EB-2022-0157

EGI Panhandle Regional Expansion Project

Oral Hearing

FRPO Compendium

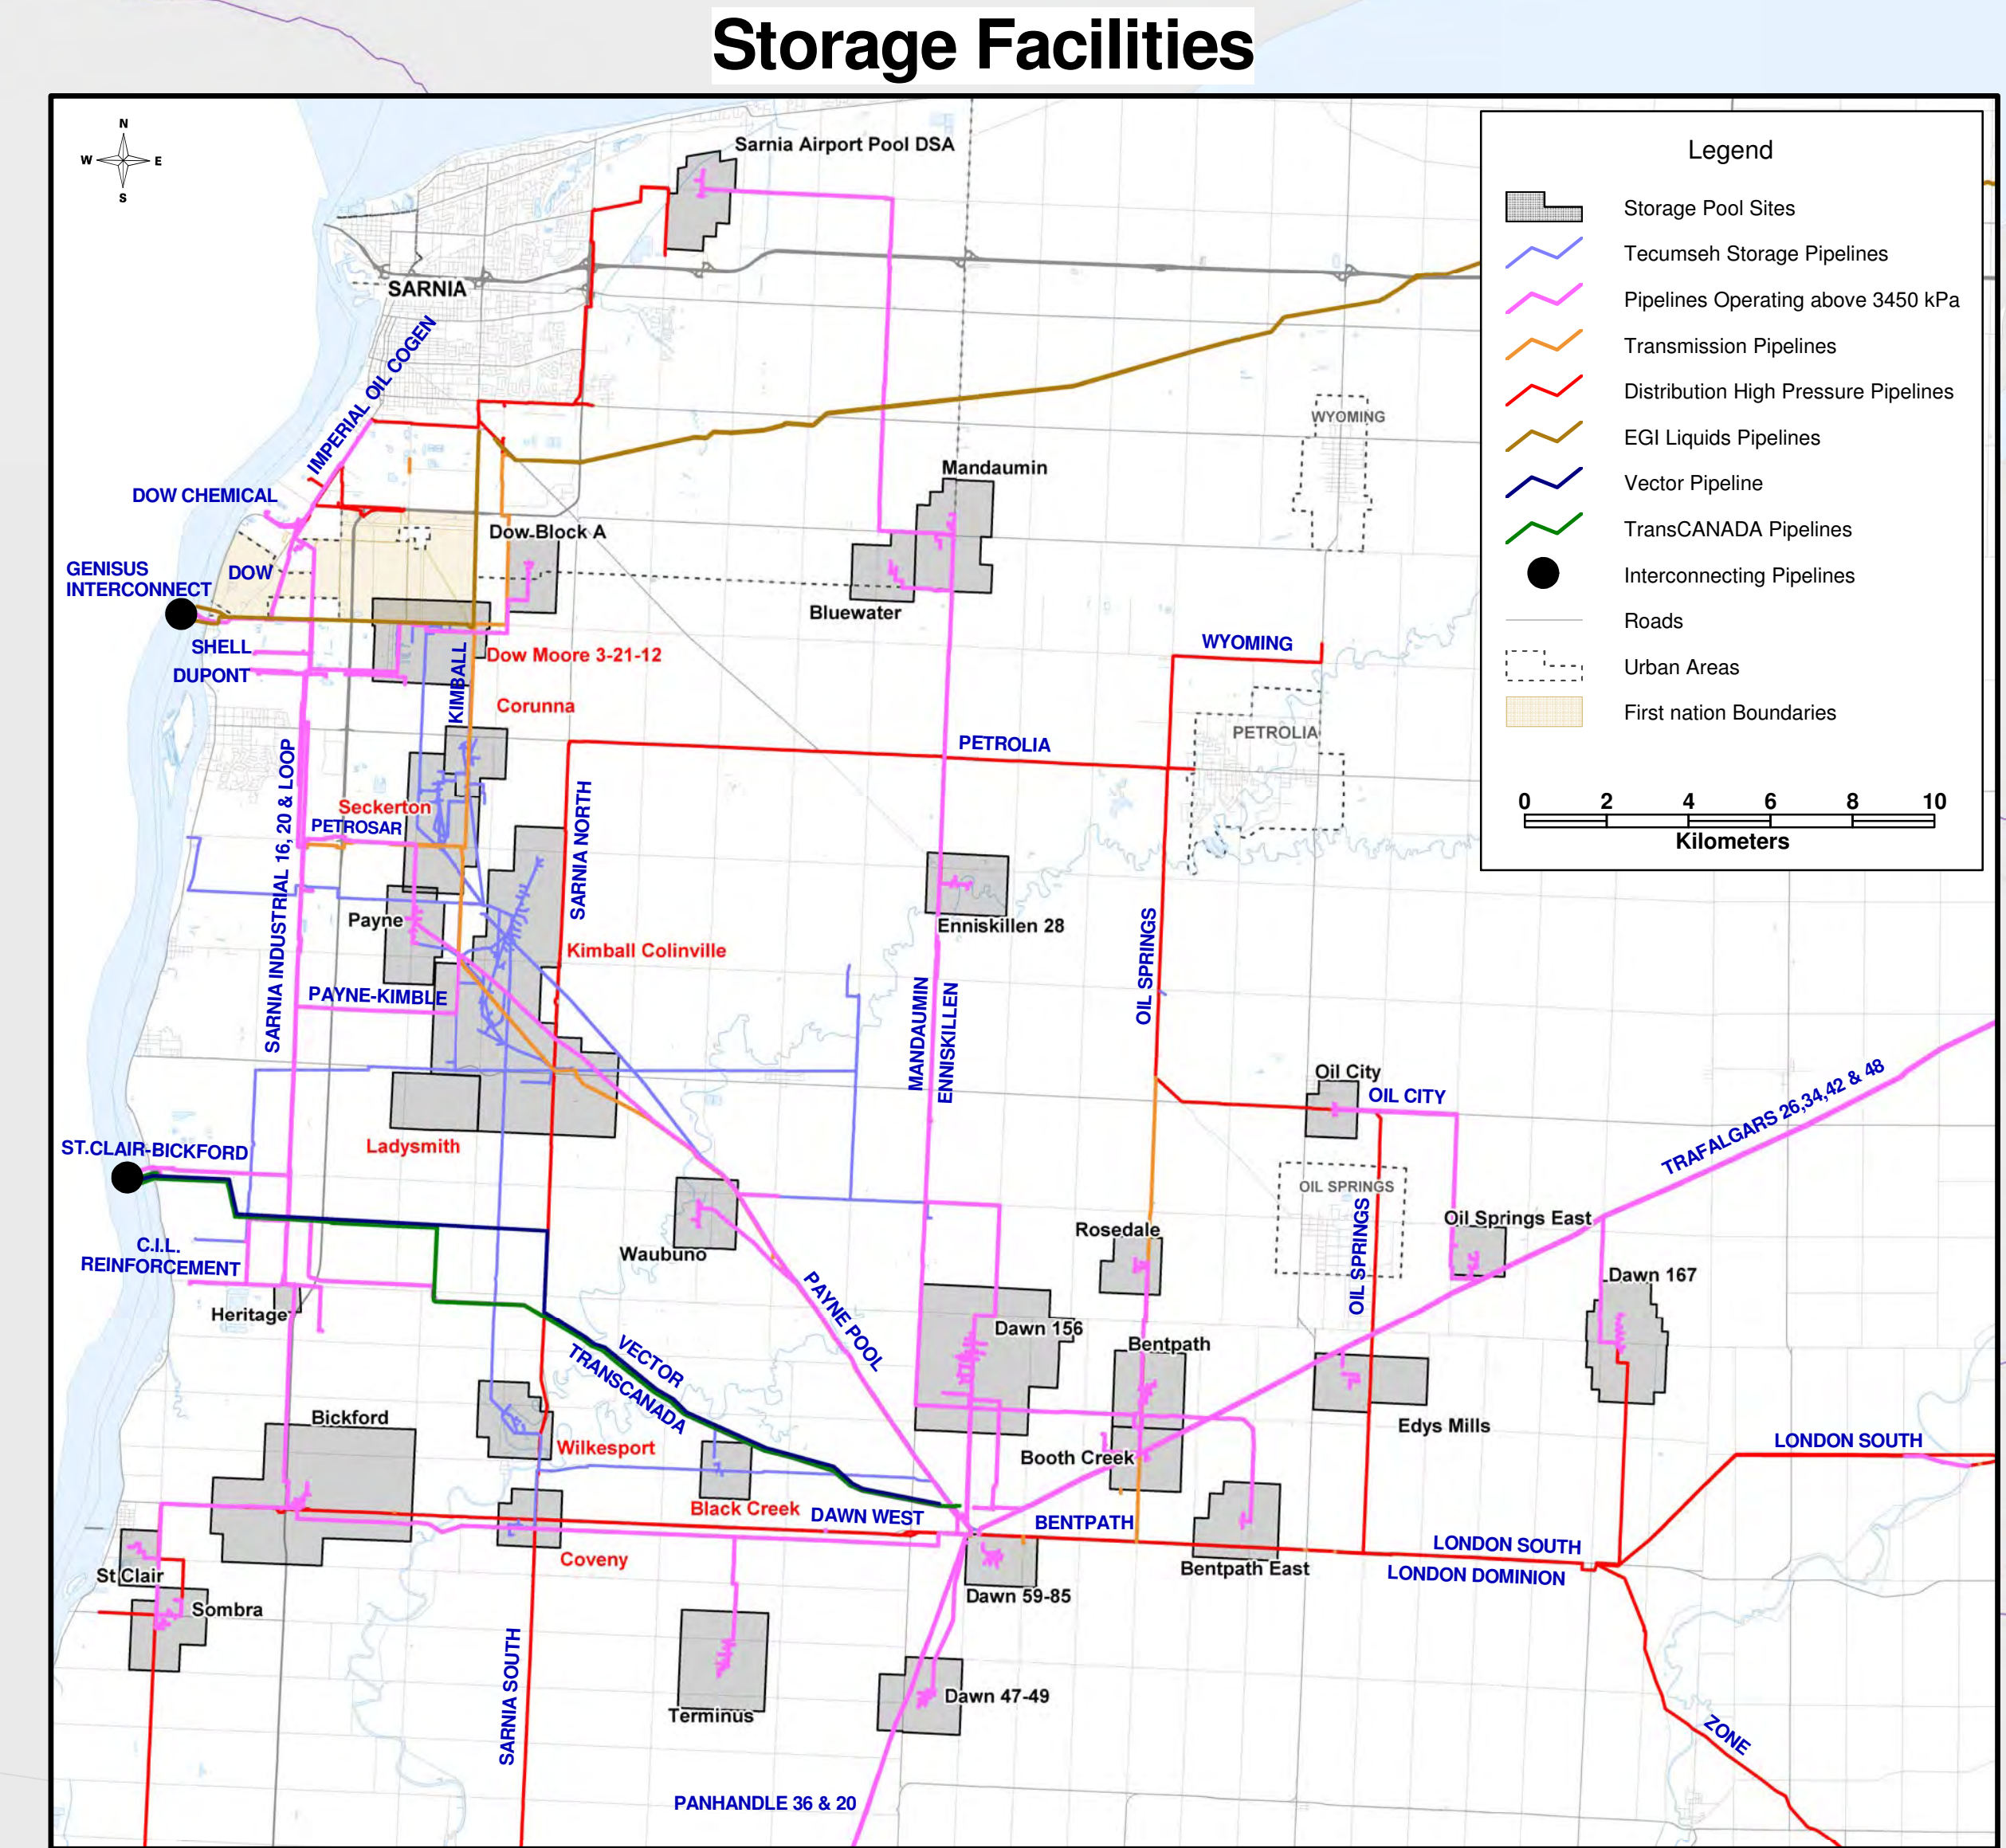
Please provide the cost estimate to modify the Sandwich compressor station to increase the Ojibway receipts to the current capacity of 217 TJ/d.

- a) Please identify any key thresholds of capacity that could be reached with limited cost to increase Sandwich above 88 TJ.
- b) Please explain why gas could not flow east past Grand Marais toward Dawn on the NPS 16.
 - i) Please provide an estimate for any changes that could be done at Grand Marais to substantially increase the market for Ojibway deliveries.
- c) How much summer and winter market will contracted demand at Stellantis and other customers in the boundaries identified by EGI (Ojibway, Grand Marais, Sandwich)

Please see the response at Exhibit I.FRPO.8 (updated October 3, 2023) for more information regarding the issue being explored by FRPO. The cost estimate to install two 3800 horsepower Compression Units at Sandwich Station is \$144M.

- i. There is no option to increase capacity at Grand Marias. In order to increase supply imports from Ojibway, Enbridge Gas would need to increase the capacity of the Detroit River Crossing, loop or upsize the Panhandle NPS 16 from Ojibway to Sandwich and add further compression at Sandwich station. For discussion regarding increasing Ojibway imports, please see the response to Exhibit.I.FRPO.8 (updated October 3, 2023). This does not address the facilities that are required on the PEPL system to deliver the necessary volume and pressure.

NPS 36 Loop (19 km) Only

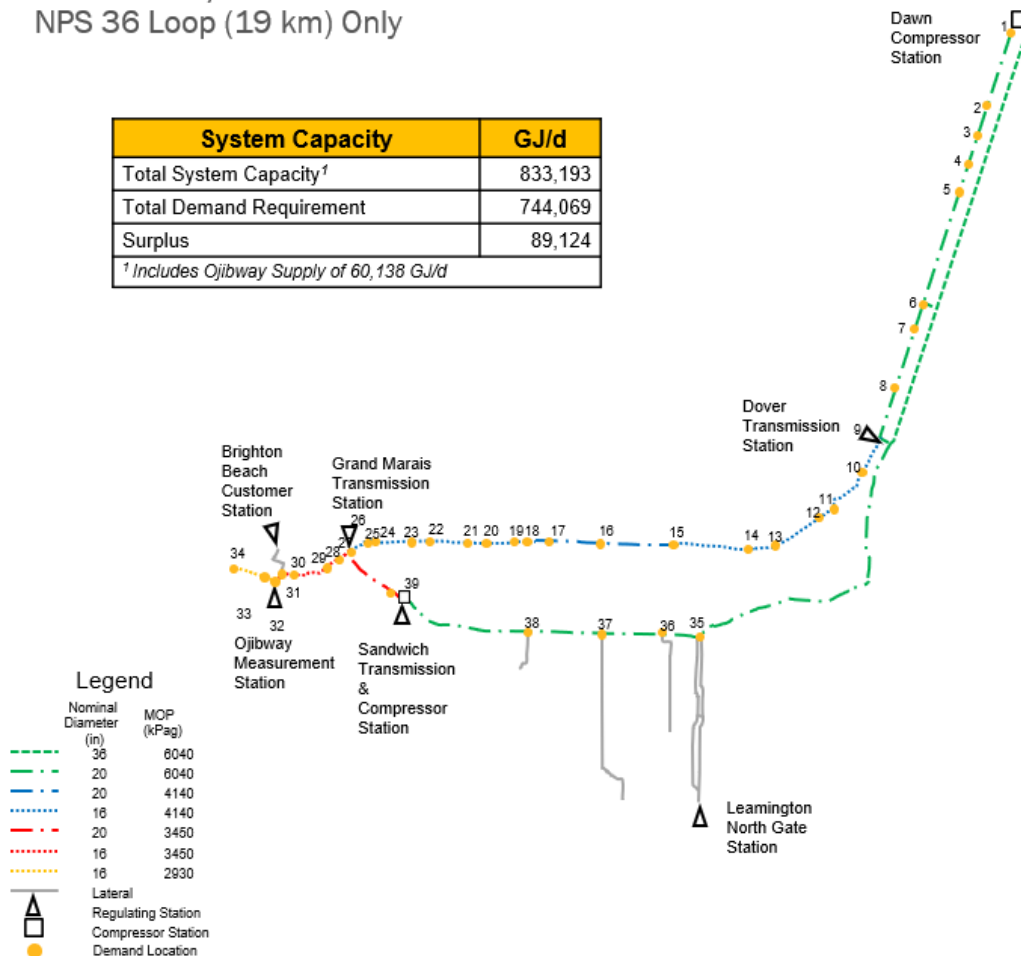
Please provide the information in Attachment 1, including the flows requested in IR#4 above, with the addition of:

- a)
 - i. Please see Attachment 1 to this response for the proposed 19 km of NPS 36 with demand for Winter 2023/2024.
 - ii. The proposed 19 km of NPS 36 with demand for Winter 2030/2031 cannot be provided as requested as the Company's hydraulic model returned an infeasible result due to extremely low system pressures, and the model would not balance. In this scenario, there is a growing shortfall from Winter 2023/2024 to Winter 2029/2030 of 244 TJ/day. When the 19 km of NPS 36 is added in Winter 2030/2031 as suggested, the shortfall drops to 67 TJ/d.
